**RE: Response to Further Request for Additional Information – DA-2020/035 – 262 Hunts Road  
Gunnedah NSW 2380**

Thank you for your letter dated 8 April 2021, which sought additional information regarding the proposed establishment of a solar farm (DA-2020/035) at 262 Hunts Road Gunnedah NSW 2380.

Please find below a response to these matters raised by the Northern Regional Planning Panel, prepared by SLR Consulting Australia Pty Ltd (Formerly KDC Pty Ltd) on behalf of Providence Asset Group (PAG).

**Image 2 - Photo 2 (Source: Mara Consulting Visual Impact Assessment)**

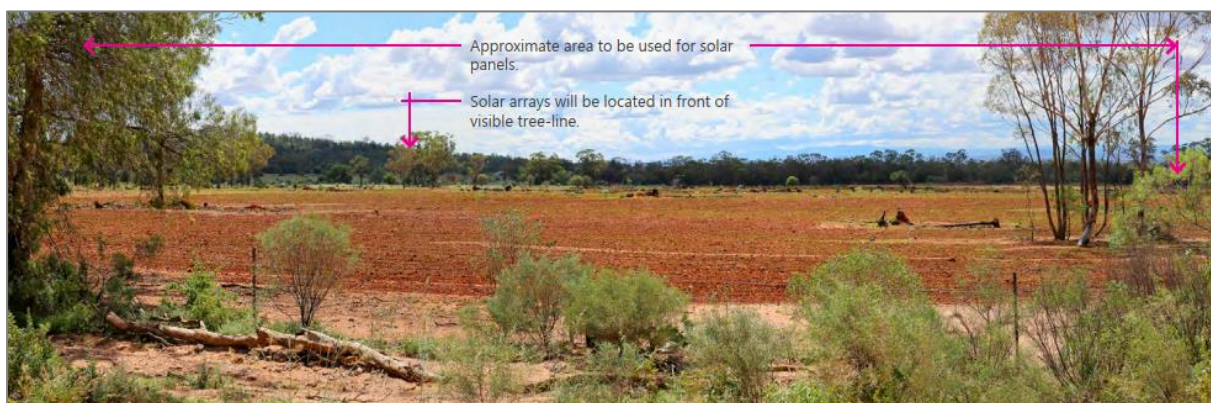
*Artist impressions are required from residential receivers identified in figure 2.3 of the Visual Impact Assessment as being visible or partly visible from that receiver. The artist impression is required to show the level of impact on private receivers, In the event that access to private property cannot be achieved, evidence of a reasonable attempt to secure access must be shown.*

Figure 2.3 of the VIA indicates that residential receivers R1, R2 and R3 are the only dwellings from which the subject site will be visible. Photographs 2, 1 and 3 of same report generally align with the dwellings (R1 = photo 2, R2 = photo 1, and R3 = photo 3). Analysis of each residential receiver below indicates that artists impressions would be of little merit in the assessment of impacts, with all identified dwellings either aligned away from, or unable to gain direct views of the proposed solar farm.

The dwelling at 170 Bushs Lane is oriented toward the north east, away from the solar farm installation. Images obtained through realestate.com.au show extensive landscaping and outdoor entertainment areas constructed to the north east of the dwelling, leading from the kitchen/living/dining areas. (image 4 and 5)

In addition, two sheds have been constructed to the north and west pf the dwelling that, combined with existing vegetation, obscure views further west to and over the proposed solar farm. (see image 3).

It is the opinion of SLR that an artist's impression of the solar farm from this residential receiver is unwarranted due to the existing orientation and the likely views obtained from the useable spaces of the dwelling.
